Proposal to replace document ECE/TRANS/WP.29/GRBP/2024/09

The changes are marked in **bold** for added text and **strike through** for deleted text, all in red font.

I. Proposal

Figure 1
Nomenclature explanation related to grip index of the tyre

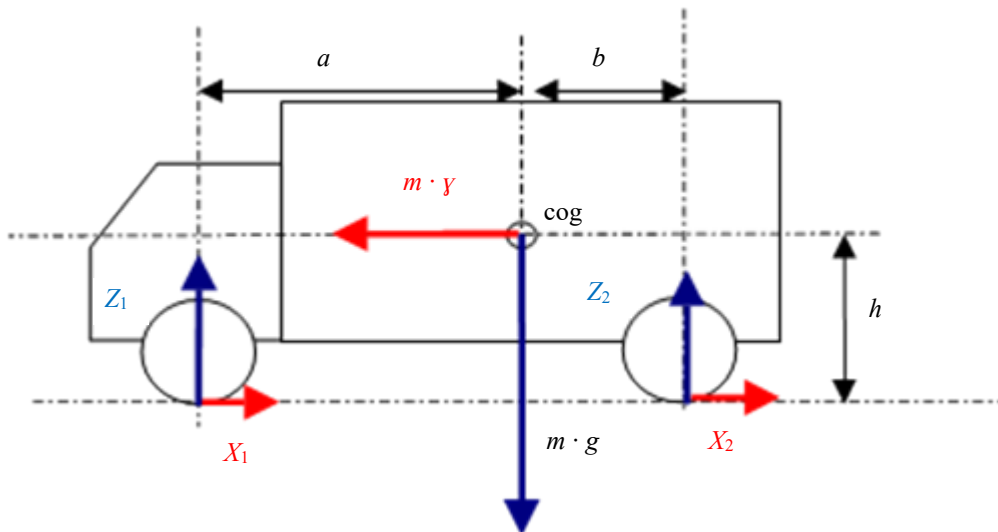
Paragraph 2.2.2.7.5., amend to read:

"2.2.2.7.5. Calculation of the relative wet grip index of the tyre

The wet grip index represents the relative performance of the candidate tyre compared to the reference tyre. The way to obtain it depends on the test configuration as defined in paragraph 2.2.2.2. of this Annex. The wet grip index G of the tyre is calculated as reported into Table 7:

Configuration C1: candidate tyres on both axles	$G = f \cdot \frac{BFC(T)}{BFC(R)}$
Configuration C2: candidate tyres on front axle and reference tyres on rear axle	$G = f \cdot \frac{BFC(T) \cdot [a+b+h \cdot BFC(R)] - a \cdot BFC(R)}{BFC(R) \cdot [b+h \cdot BFC(T)]}$
Configuration C3: reference tyres on front axle and candidate tyres on rear axle	$G = f \cdot \frac{BFC(T) \cdot [-a-b+h \cdot BFC(R)] + b \cdot BFC(R)}{BFC(R) \cdot [-a+h \cdot BFC(T)]}$

<i>For class C2 tyres</i>	
SRTT16C	
$f = 1$	
<i>For class C3 tyres</i>	
SRTT19.5, SRTT22.5	SRTT19.5 siped, SRTT22.5 siped
$f = 1$	f = 1.04 1.02

Where (see also Figure 1):

f: correction factor depending on used SRTT
